Re: "Assessment of Dam Safety Coal Combustion Surface Impoundments (Task 3) Final Report" for Georgia Power Plant Branch, Milledgeville, Georgia

**Re: Additional Information in Response to “Assessment of Dam Safety Coal
Combustion Surface Impoundments (Task 3) Final Report” for Georgia Power
Plant Branch, Milledgeville, Georgia**

Plant Branch Ash Pond C, East Dike (Photo 1) Shows area regraded and water rerouted away from dike

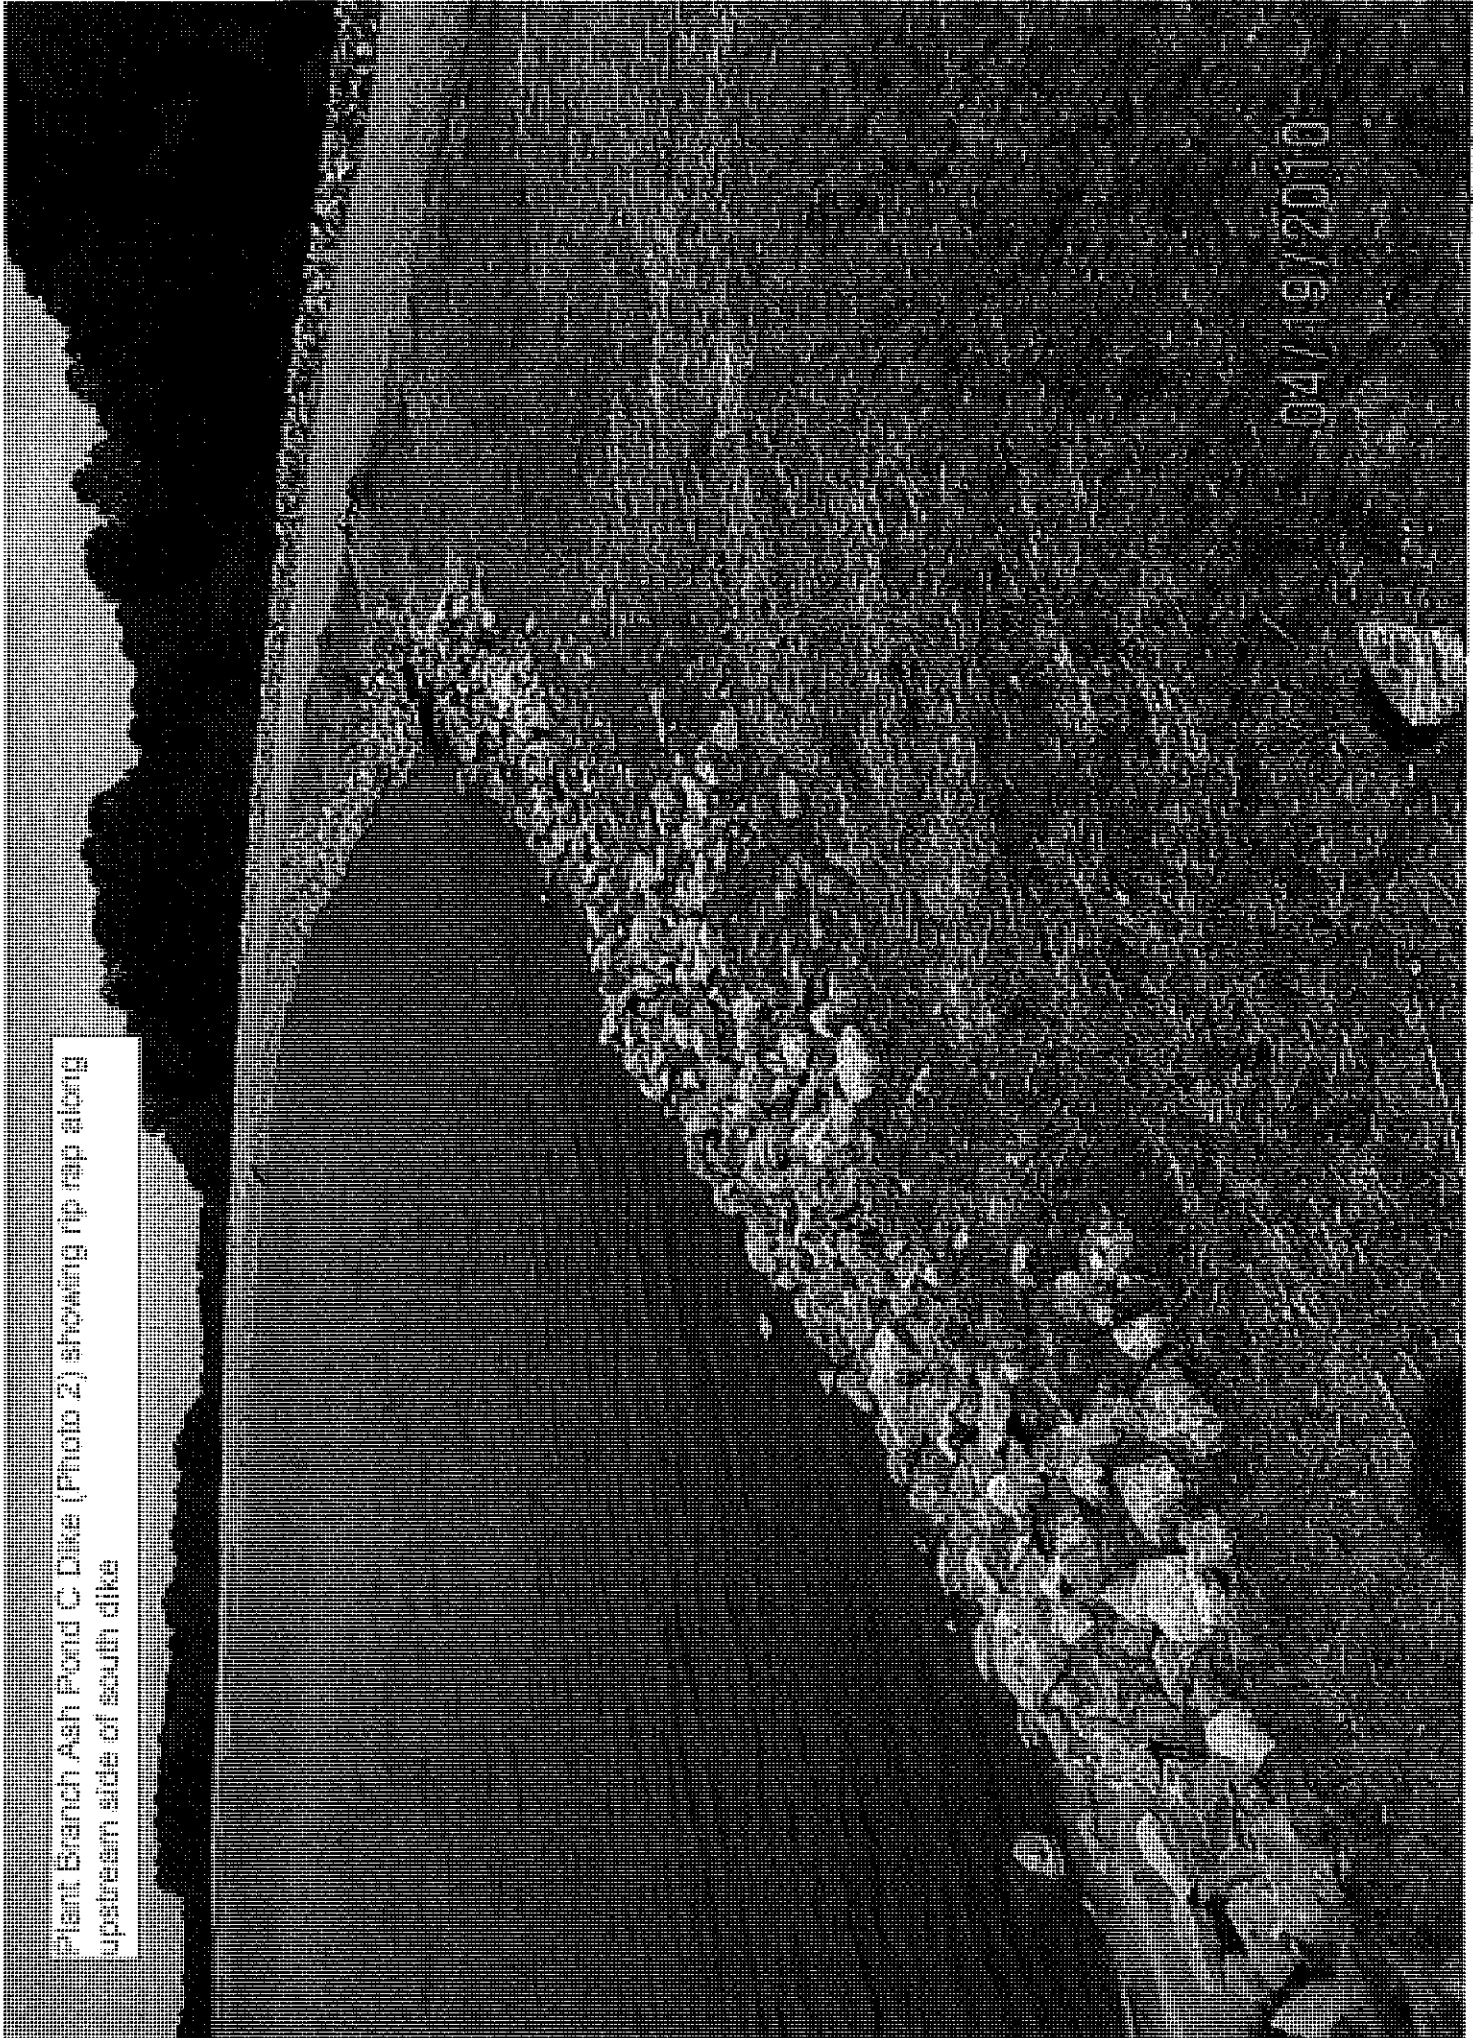
- *Saturated soil conditions were also noted north of the recycle water pump station. We understand that Georgia Power has placed rock in this area previously and the wet conditions have continued. CHA recommends that Georgia Power consult with a geotechnical engineer to develop recommendations for this area.*

Georgia Power has completed grading in this area to route water to Ash Pond B. Photo documentation is attached (Photo #1). This should close out this issue.

Plant Branch Ash Pond C Dike (Photo 2) showing rip rap along
upstream side of south dike

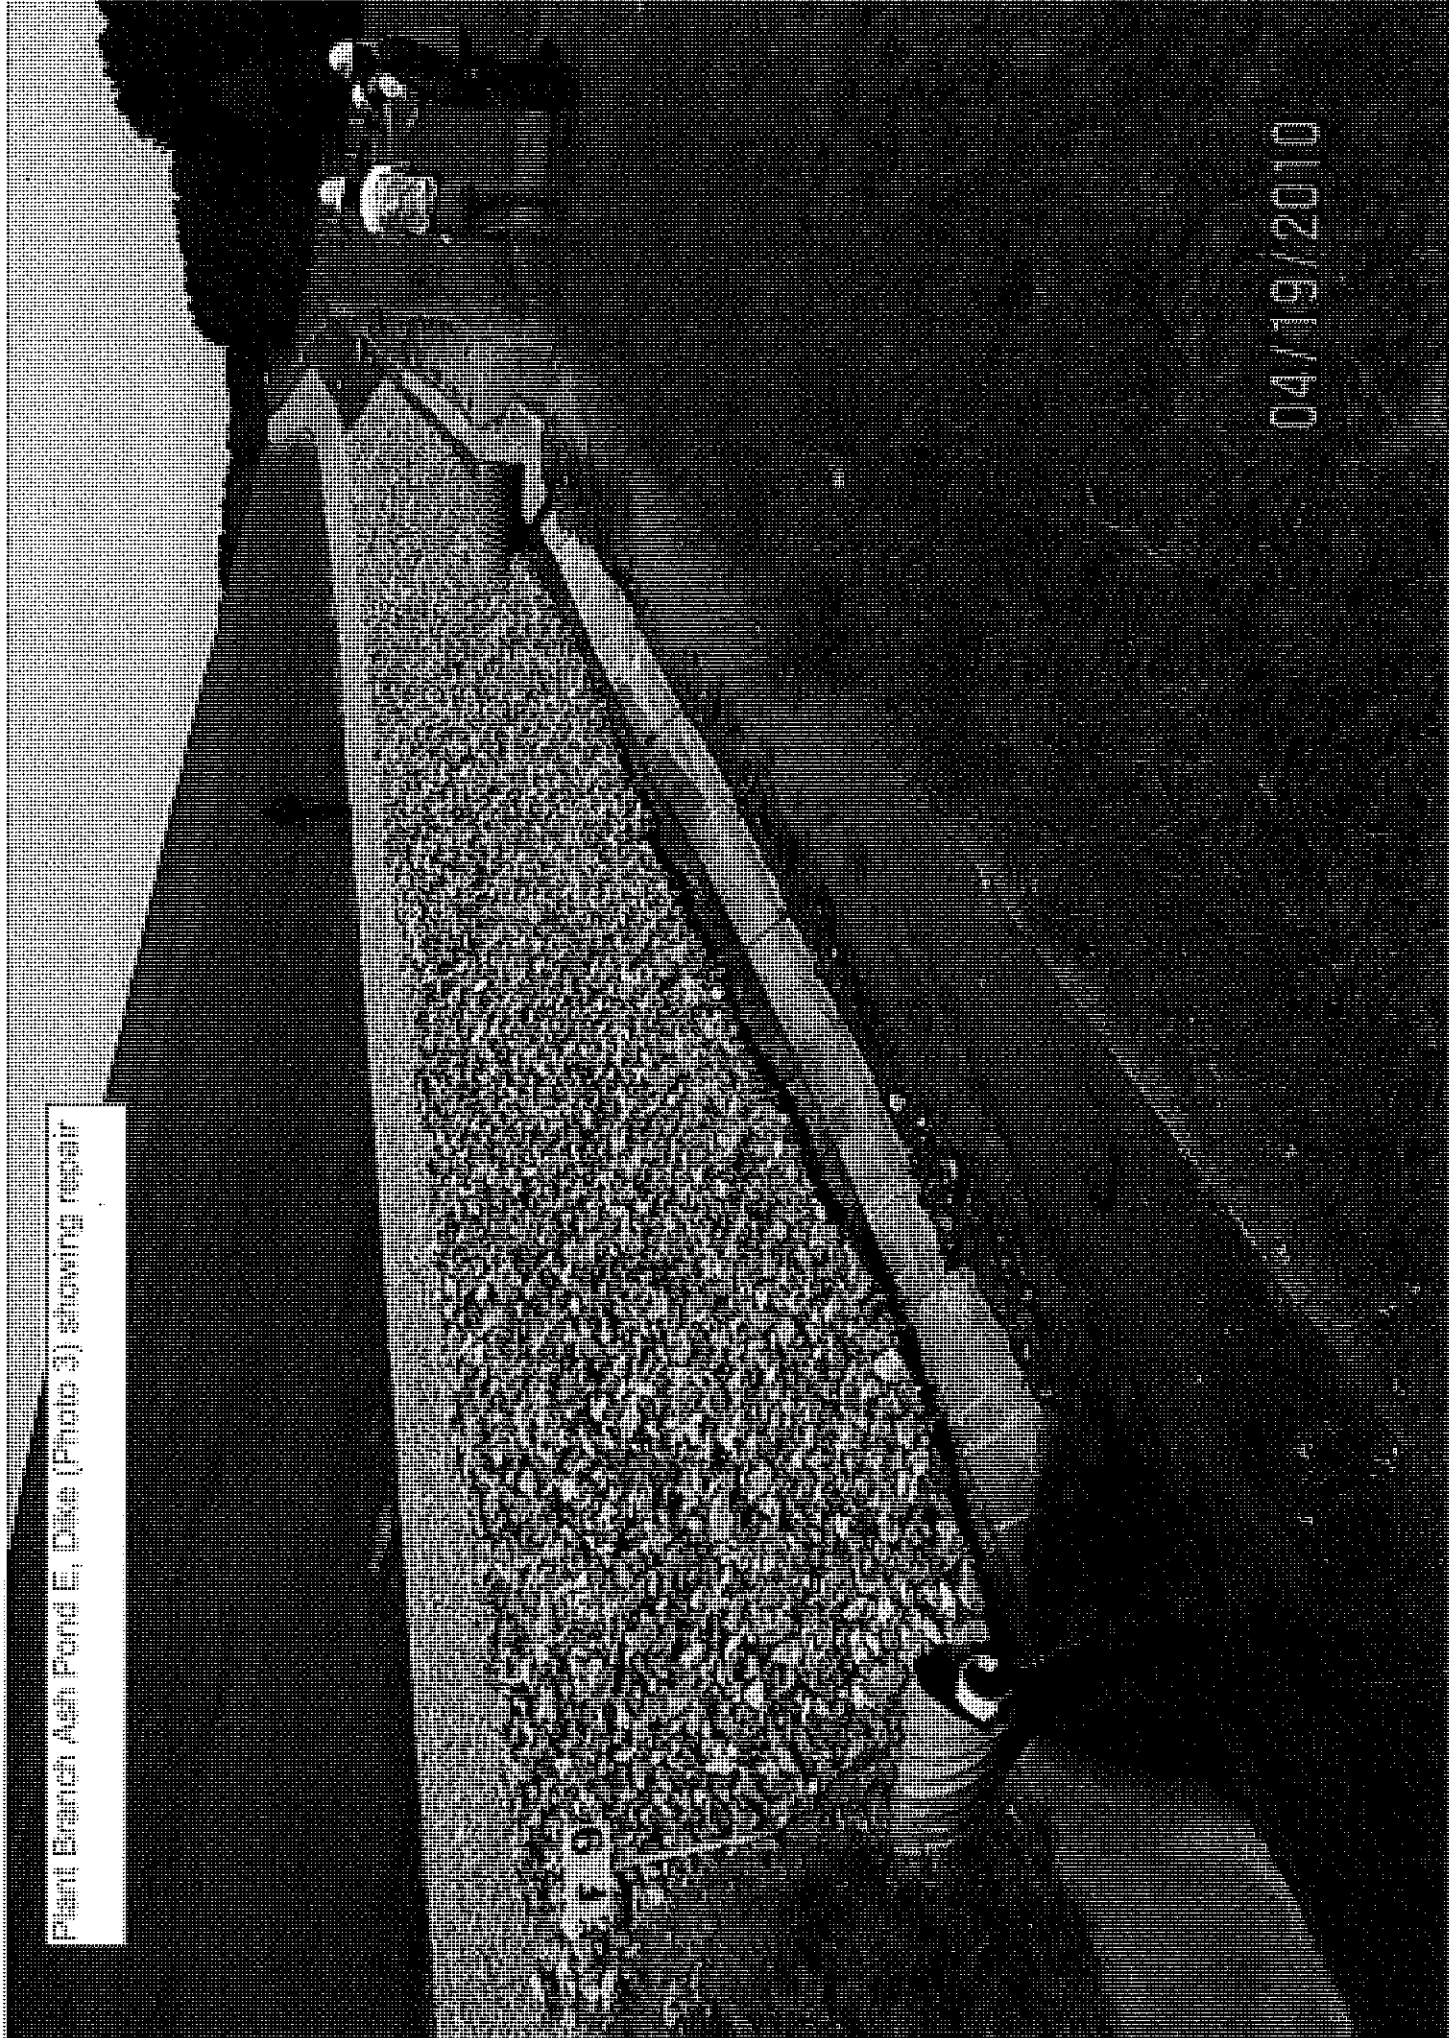
- *Erosion due to water "lapping" the surface was observed on the upstream side of the south dike. CHA recommends improvements to the erosion protection along the water's edge. Georgia Power has indicated that this has been completed since CHA's site visit.*

Rip rap has been placed on the upstream side of the south dike for erosion protection. Please reference attached the photo documentation (Photo #2).
